Jacobs Engine Brake™ Service Letter E491

SUBJECT: Defective Slave Pistons

MODELS AFFECTED: 770, 750B

DATE: February 1, 1999

Figure 1. Inspection for Slave Piston cross-drilled hole.

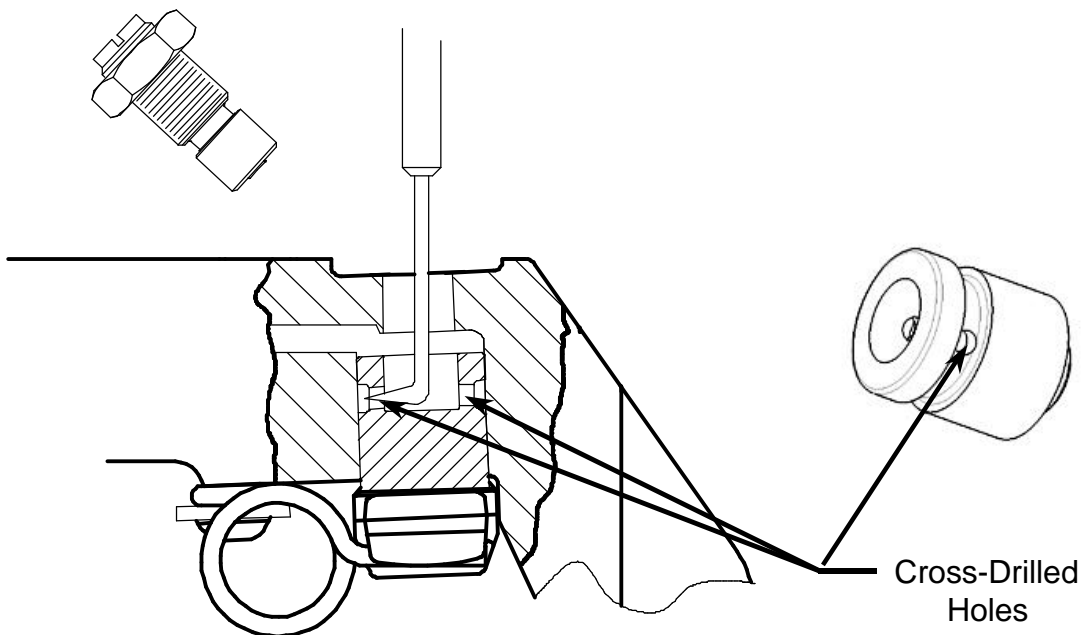
- (6) Using a light source, inspect the slave piston to assure the presence of a cross-drilled hole. There are 2 holes per piston. If you cannot see a cross-drilled hole, a bent wire or mechanic's scribe may be used to probe for the presence of a cross-drilled hole (See Figure 1.)

- (7) If no cross-drilled hole can be found, the housing must be removed for re-work and an inspection must be made to assure valve damage has not occurred.

- a) Using a set of standard feeler gages, measure the exhaust valve lash. Normal exhaust valve lash is .026". If exhaust valve lash exceeds .031", valve damage may have already occurred, refer to Detroit Diesel service procedures for servicing the cylinder head.

- b) Refer to the Series 60 or Series 50 engine service manual as necessary for the removal, disassembly and assembly of the engine brake housing. During re-assembly, be sure to install new J-Lash adjusting screws part number 28082 and slave pistons with cross-drilled holes.

- c) Re-install the engine brake following the procedures in the Series 60 or Series 50 service manual.
- (8) If the presence of a cross-hole in each slave piston can be confirmed visually or with a probe, the engine brake housing does not need to be removed, and there is no danger of engine damage from the engine brake.
